**Applicant's Response Letter to the appeal dated
March 25, 2019**

Re: Public Market Parcel B – Response to Appeal

EMERYVILLE PUBLIC MARKET - PARCEL B
Emeryville, California

Exhibit A – PDP Conformance

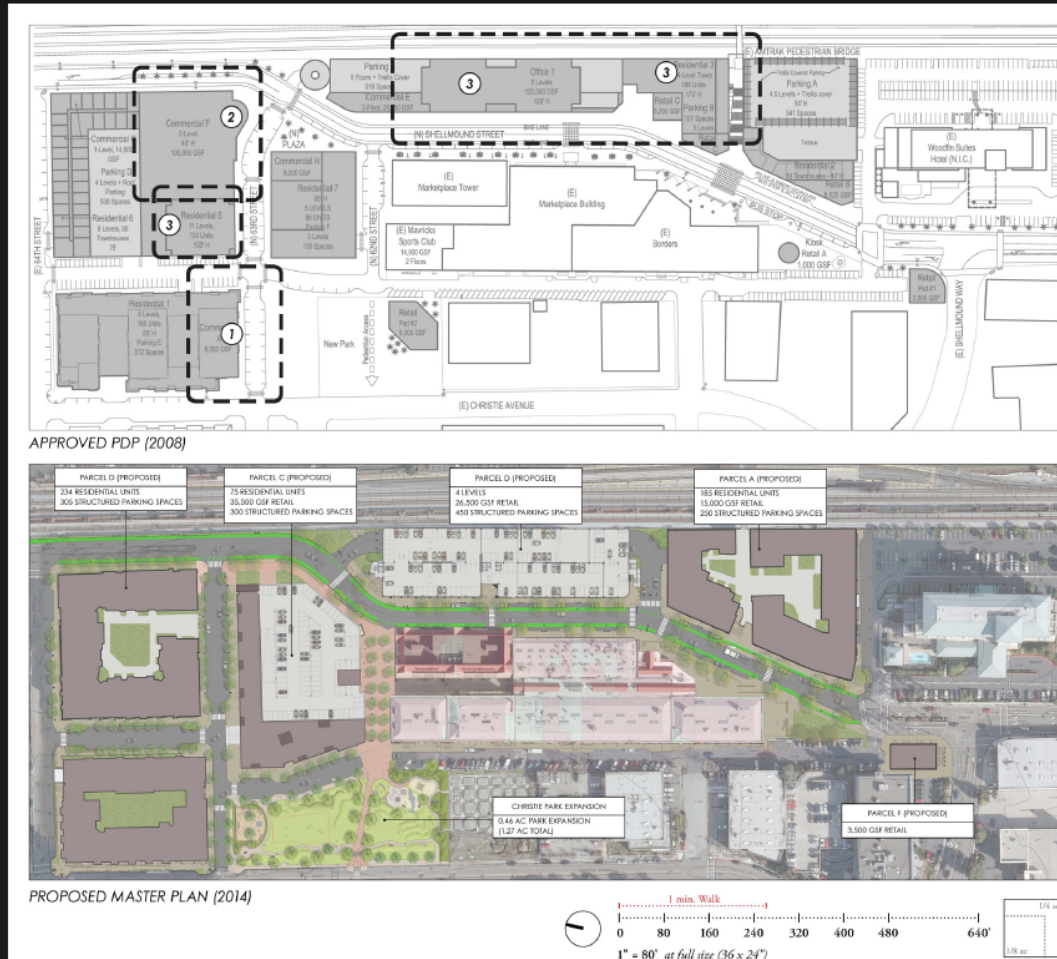
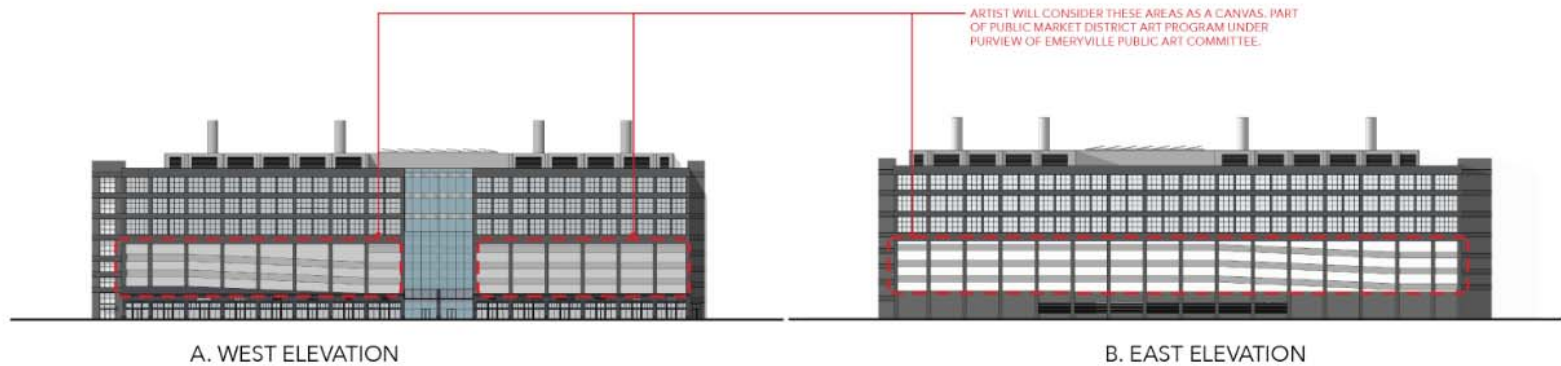
The project's design, extremely close to the equally tall and boxy existing Marketplace Tower to its west, will create a stark and dark cavern between them which will make the retail at their bases very uninviting public spaces. The proposed design indeed could not be more boxy,

antithetical and contrary to this requirement. The original 2008 approval indeed included large buildings along the railroad tracks. However, in that original approval they have varying and modulated heights and facade, with several important openings and livable gaps between different building masses.

impacts than the original PDP. The approved PDP allowed a height of 120 feet on Parcel B. The proposed Parcel B building is 112 feet. As shown in the attached Exhibit A – PDP Conformance, the original PDP contemplated a much taller tower on Parcel A up to 175 feet. The approved Parcel A allows a height of up to 86 feet on the northern portion of the building and a height of up to 50 feet on the southern portion of the building structure. Altogether, Parcels A and B will allow for a less monumental sightline.

Exhibit E – East Elevation Comparison

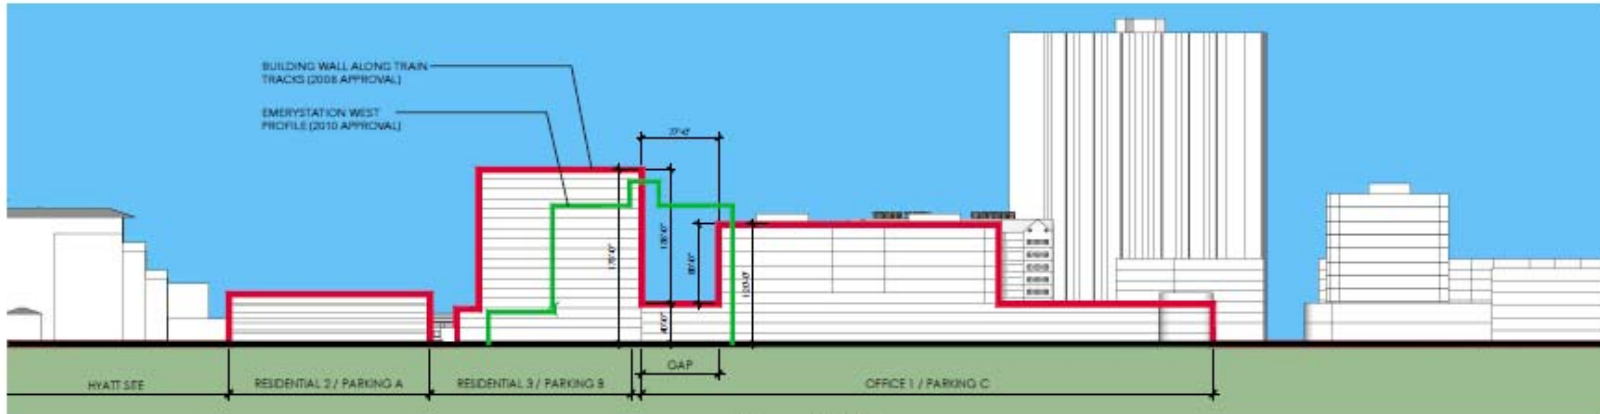
The prior approved design for Parcel B had a roughly 170 foot gap between it and the approved Parcel A building. The most recent approved design reduced the gap by almost half, to only less than 80 feet. This narrow gap eliminates any real visual connection between the eastern side of the railroad station and EmeryStation campus and the Marketplace, while increasing negative wind patterns. This is not to mention the fact that the prior wider gap was filled with a single-story retail pad building, possibly a restaurant, which would be an attractive area of activity. The current narrow gap only houses the dumpster that will serve the new building.

Further, the appellant references a previously approved 170 foot gap between Parcel B and the approved Parcel A building. This references the previously approved Parcel B FDP allowing retail and parking. It has been determined that the prior Parcel B FDP is not economically feasible. The proposed Parcel B FDP proposes a gap similar to that in the relevant PDP, as shown in the attached Exhibit E – East Elevation Comparison.

WALL AREA ALONG TRAIN TRACK FRONTAGE	Δ
Figure 1, PDP	85,021 SF	-
Figure 2, FDP	72,748 SF	15% LESS
